CITY PLANNING COMMISSION

- . Negative Declaration
- B. Special Permit to construct two office buildings totaling 60,000 sq. ft.

LOCATION: Northwest corner Gateway Oaks Drive and Venture Oaks Way.

APPLC.NO P87-320 MEETING DATE: August 13, 1987 ITEM NO 17

SITE PLAN

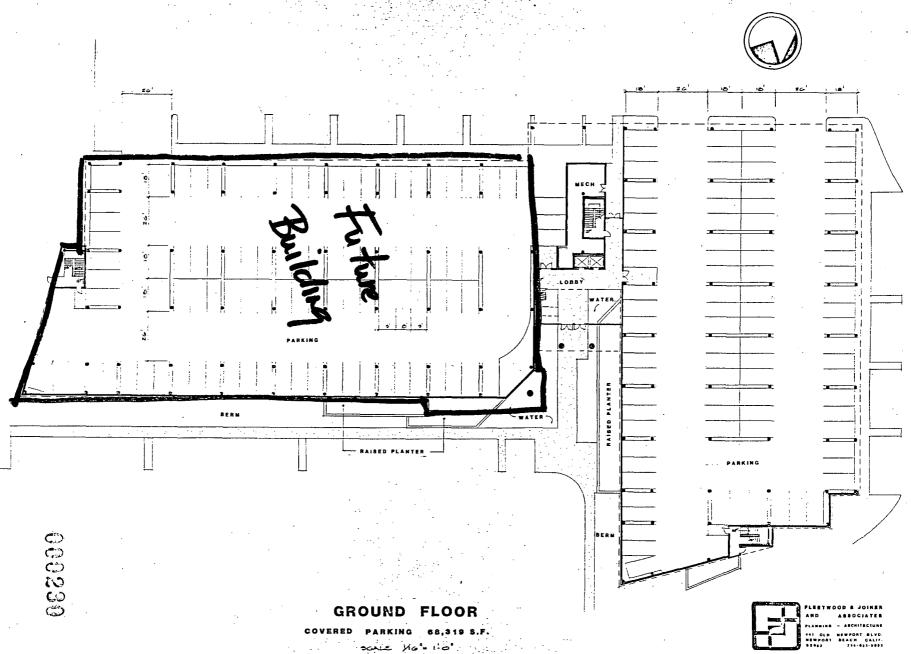
The site plan indicates that the required 50 foot landscape/building setback along the Gateway Oaks Drive will be provided. A 50 foot building setback and 25 foot landscape setback are required along the Venture Oaks Way frontage. The site plan indicates the building B has a setback of 43 feet from the property line along Venture Oaks Way. The site plan must be revised to reflect a 50 foot setback.

The applicant will provide 240 onsite parking spaces. Parking will be provided both inside the building and in the parking lot. The site plan does not indicate the location or number of handicap parking spaces. In addition, no bicycle parking spaces are shown, however 16 spaces are required of which 50 percent must be Class I parking facilities. The site plan must be revised to indicate these items.

- 1. A revised site plan and landscape plan shall be submitted to the Planning Director for review and approval prior to the issuance of building permits which incorporate the following changes:
 - a. indicate location of 16 bicycle parking spaces (50 percent Class I):
 - b. indicate Building B setback of 50 ft. on Venture Oaks Way; and
 - c. landscape berms along the street frontages shall be a minimum of three feet high.
- 2. All trash enclosures shall be constructed to the standards outlined in Section 3 of the Zoning Ordinance.
- 3. The applicant shall submit a sign program for review and approval by the Planning Director prior to issuance of sign permits.

LANDSCAPE PLAN

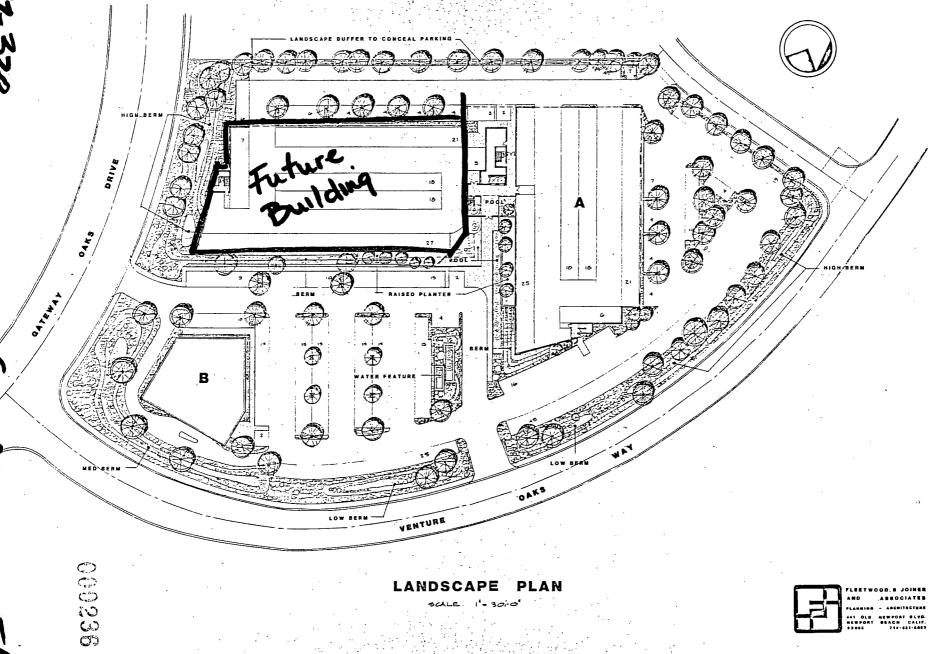
The landscape plan includes complete landscaping of all required setback areas using sod, ground cover, trees and berms. The parking lot will need to comply with the 50 percent shading requirement. A water feature will also be located in the parking lot planter nearest the building A entry.

- 5. The applicant shall comply with the 50 percent parking lot shading requirement.
- 6. The applicant shall adhere to all provisions of the South Natomas Office Park PUD guidelines (Gateway Center).
